## The Deputy Secretary of Energy

September 8, 2010

On August 6, 2010, you requested that the Department of Energy (DOE) respond to questions regarding plans and processes for the Waste Treatment and Immobilization Plant (WTP) being designed and constructed at the Hanford site. The DOE's responses to your questions are enclosed.

# **Responses to Defense Nuclear Facilities Safety Board Questions**

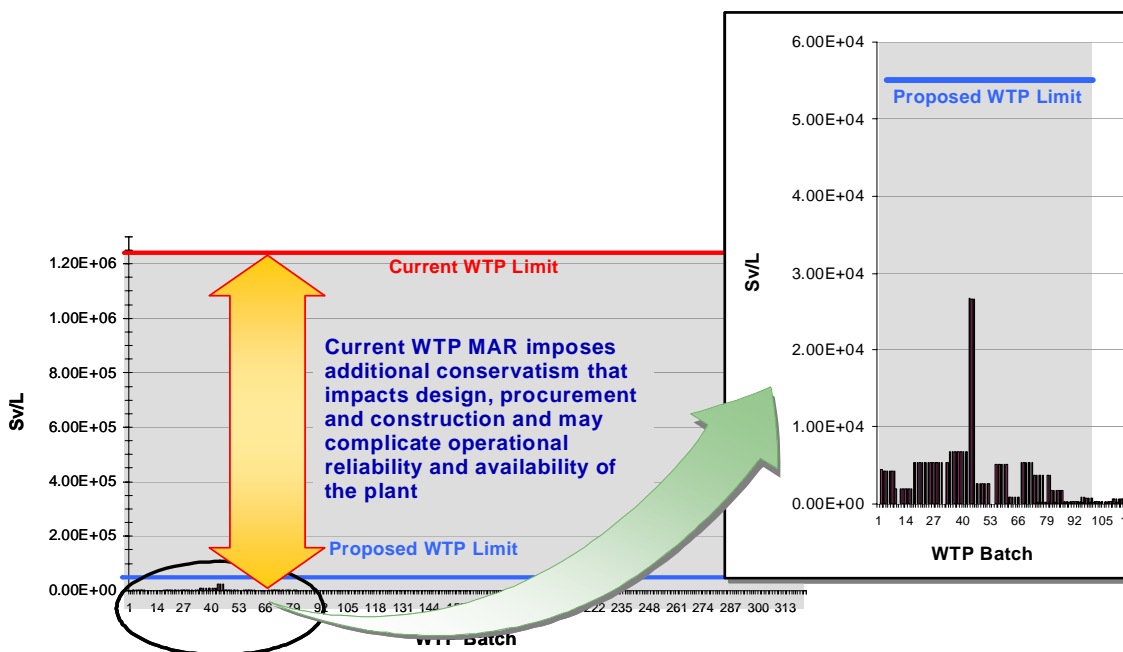
The change in MAR and the remaining conservatism are illustrated in the following figure taken from the November 2009 DOE Safety Evaluation Report (SER) approving the MAR change.

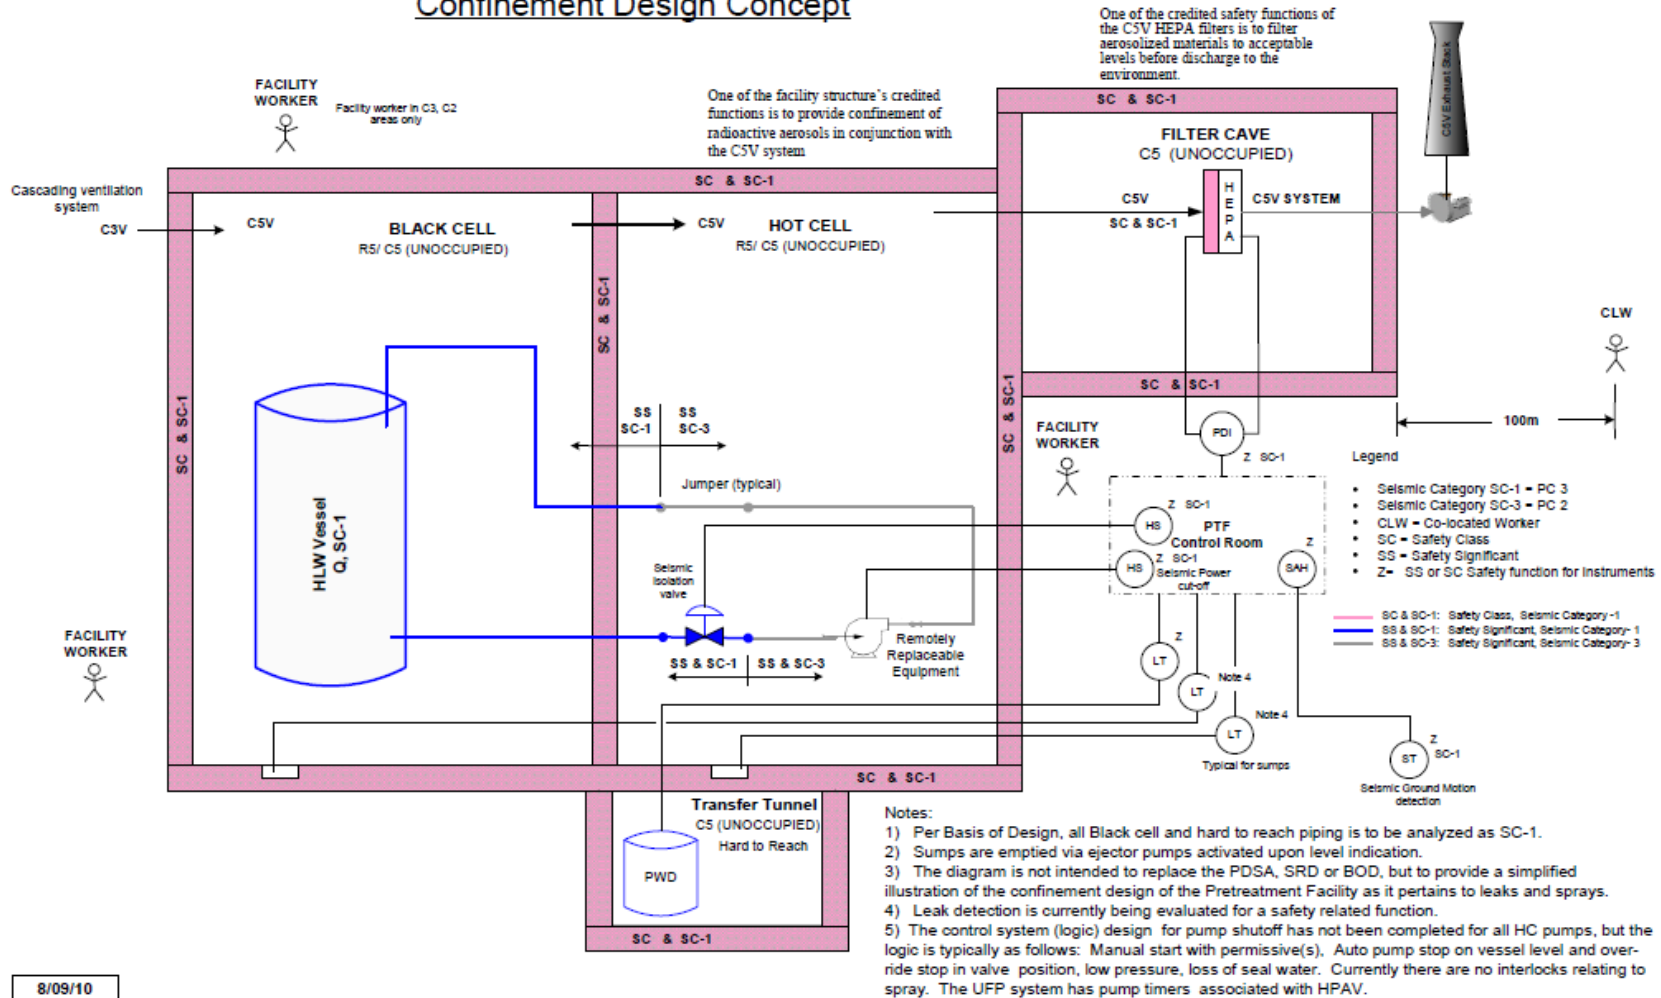
The effectiveness of these requirements is illustrated in the attached figure (see page 4) which depicts the many barriers afforded by the project's control strategy to protect workers outside the hot cell. This figure on page 4 provides a simplified depiction of the PTF confinement boundary.

## HLP-22-NQA-007 Test Results

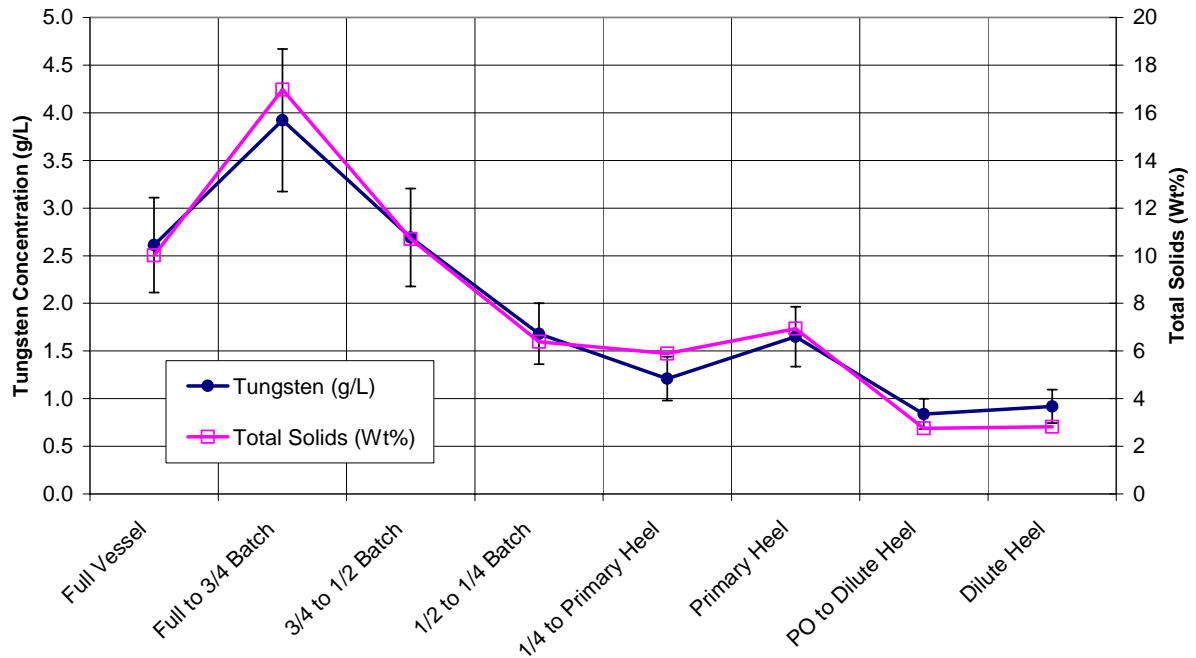
More specifically, the tests completed at the MCE test stand for the HLW Feed Receipt vessel (HLP-22), which is the primary location for the criticality sampling, indicated that large, high settling rate particles were removed from the test vessel relatively early as the test vessel was emptied, and the smaller, low settling rate particles were dispersed more uniformly in the slurry and were pumped out at a more consistent rate. Examples of the large particles would be the sand and  $\sim 700\mu\text{m}$ , 2.9 g/mL simulant particles. The aluminum and iron particles are examples of the smaller, well distributed particles. Based on the maximum observed particle size data presented in Table 3.2.18 of WTP-RPT-153, the waste Fe, U, Bi, Ni, and Mn compounds would be expected to be in the well distributed particle set.

A related question is the behavior of the  $\text{PuO}_2$  simulant particles in these tests. Although most of the Hanford plutonium is expected to have formed co-precipitated particles with the iron and other waste elements, a very limited number of tanks are suspected to contain  $\text{PuO}_2$  particles, bounded by a  $10\mu\text{m}$  spherical equivalent particle, that are not co-precipitated (CCN: 211814, p. 4, 1st paragraph). These plutonium oxide particles were simulated with a tungsten carbide (WC) alloy. The WC alloy particles ranged from  $\sim 1\mu\text{m}$  to  $30\mu\text{m}$  diameter (CCN: 214953, p. 8). The tungsten concentration as a function of the tank level results from the HLP-22-NQA-007 test shown below clearly shows that the tungsten concentration during the first pump-out was higher than the original full vessel level (which would result in a conservative sample) In addition, the tungsten concentration in the heel slurry remaining after the initial pump down is lower than the initial, full vessel concentration.
